**The Metropolitan Borough of Stockport (Hazel Grove (A6) to Manchester Airport A555 Classified Road) Compulsory Purchaser Order 2013 and**

**The Metropolitan Borough of Stockport (Hazel Grove (A6) to Manchester Airport A555 Classified Road) (Side Roads) Order 2013**

**Public Local Inquiry – 30<sup>th</sup> September 2014 – Proofs of Evidence**

**Proof of Evidence of  
John Seed MA (Oxon) FRICS FAAV  
For  
Mrs Angela Mary Rowland**

**The Authority's Drawing No. 1007/3D/DF7/A6/MA/GA/308 to show width of existing  
access track**

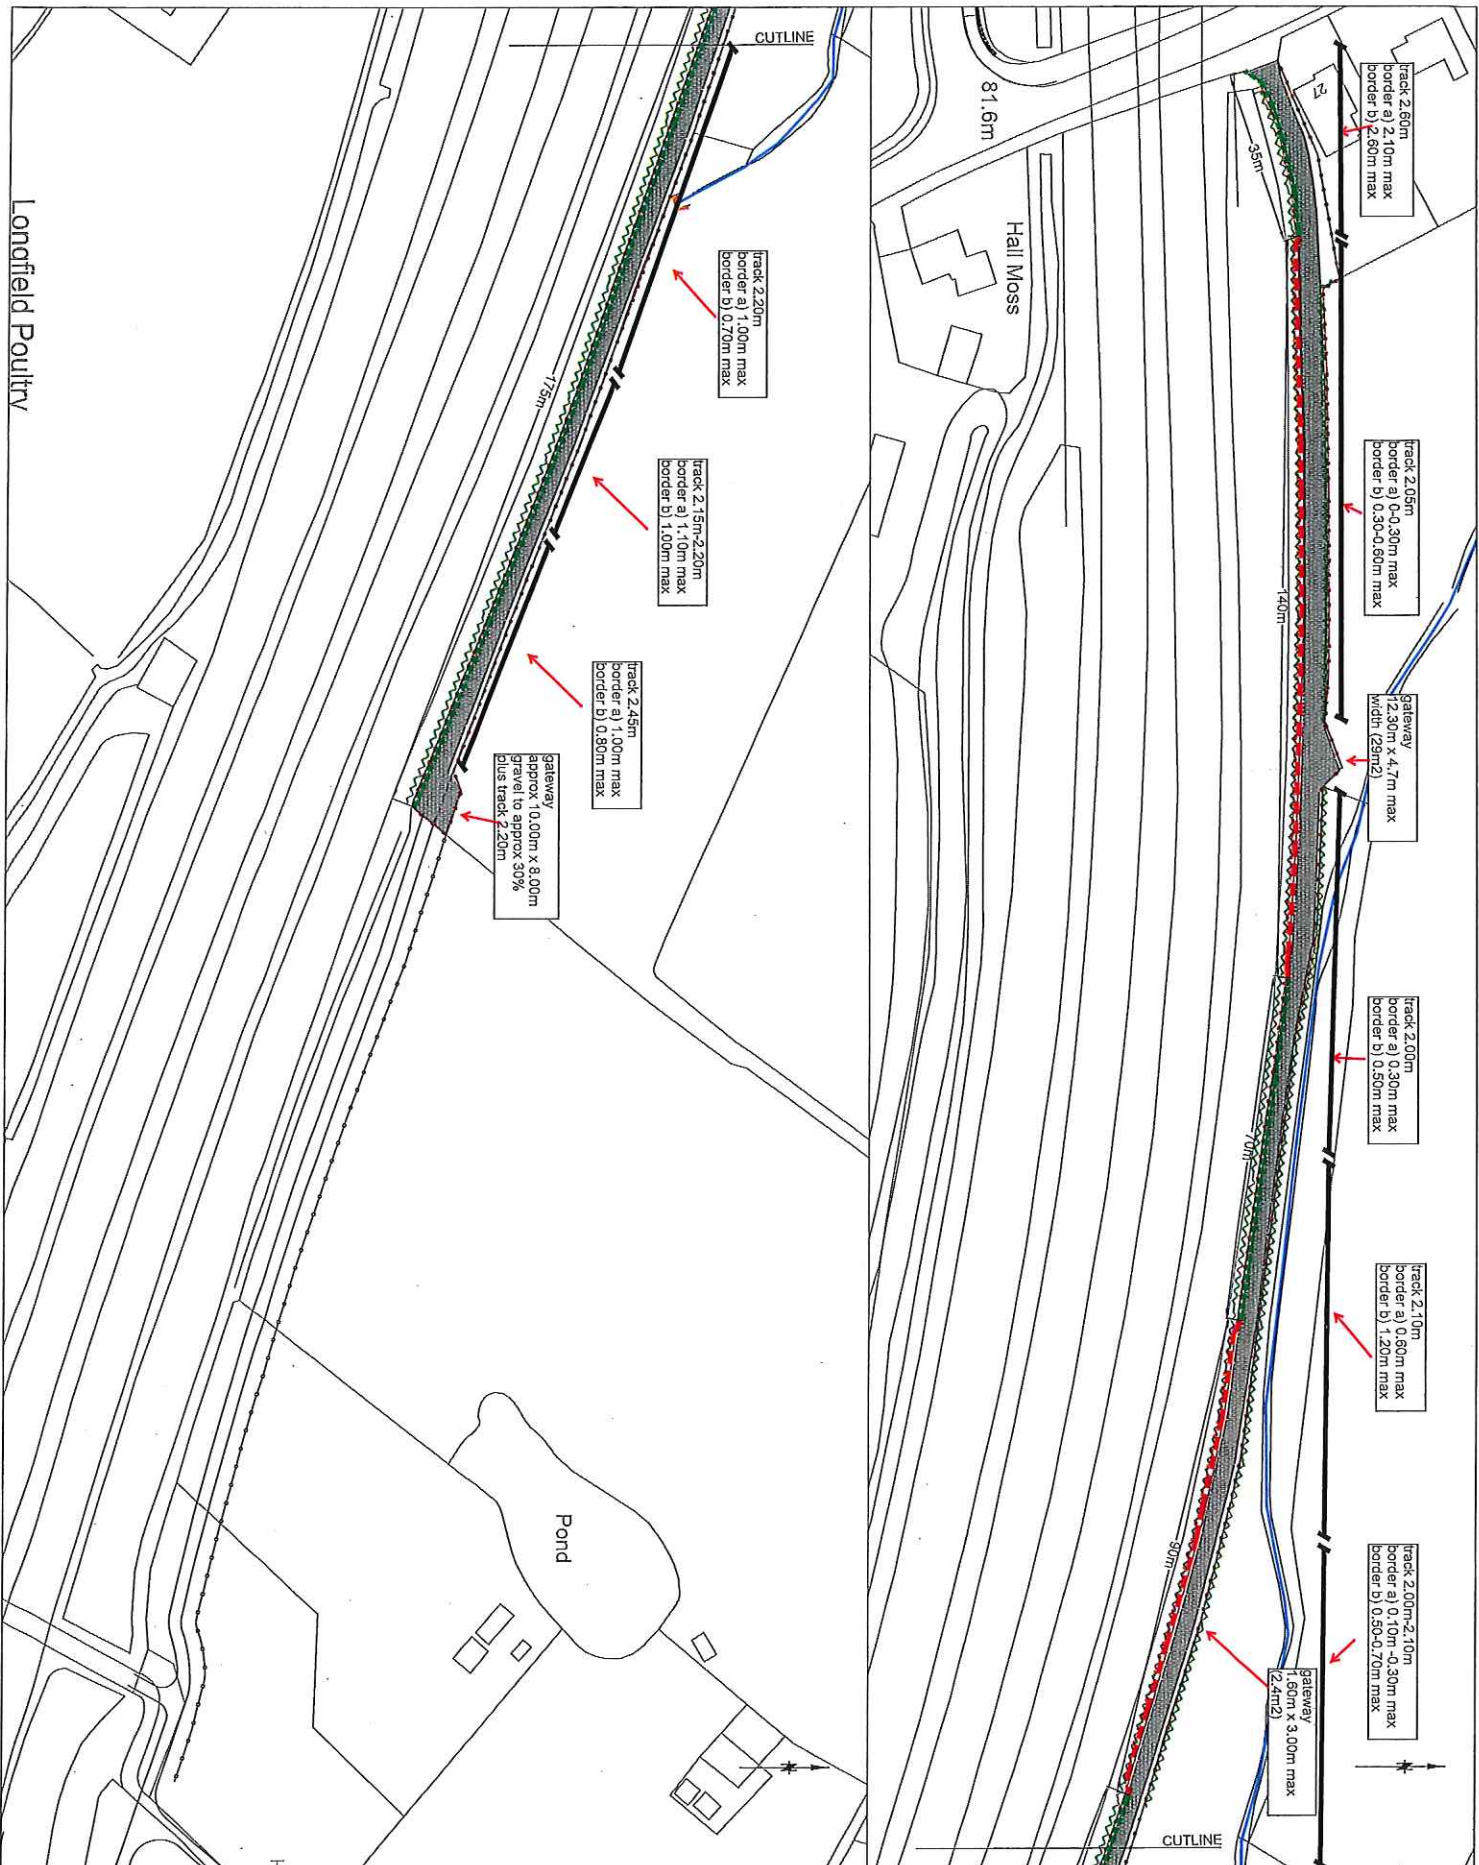
- 5.4 There is a sufficient footpath network in the area.
- 5.5 The existing track is in practical terms not wide enough for modern agricultural traffic: tractor widths are routinely 2.4 metres and hay harvesting equipment 2.6 metres: these compare with the current track width shown on the drawing at Appendix 1.5.2. The measurements taken on site for Appendix 1.5.2 followed hedge cutting; when hedges grow out, the practical widths available are less. There is insufficient width for modern farm machinery and other traffic to pass along the existing track.

- 5.11 The Authority's first response to our clients concerns was to design occasional passing places. This proposal does not deal with our clients concerns as new users of the bridleway will not necessarily give way to existing agricultural traffic, meaning that agricultural traffic may have to reverse to the nearest passing place (notwithstanding any cyclists, horse riders etc. behind as well as in front of the vehicles).

- 5.13 The Authority's second response was to widen the track by 1 metre (possibly including fencing). This was proposed in the email referred to above of the 5<sup>th</sup> August 2014 in which it was stated "SMBC has modified the scheme to allow for the widening of the line by 1 metre along its length, as per the attached plan. Please advise your clients accordingly." The latter comment is symptomatic of the Authority's attitude – it prefers to impose solutions rather than consult and discuss them. The additional 1 metre width is insufficient for horse riders.
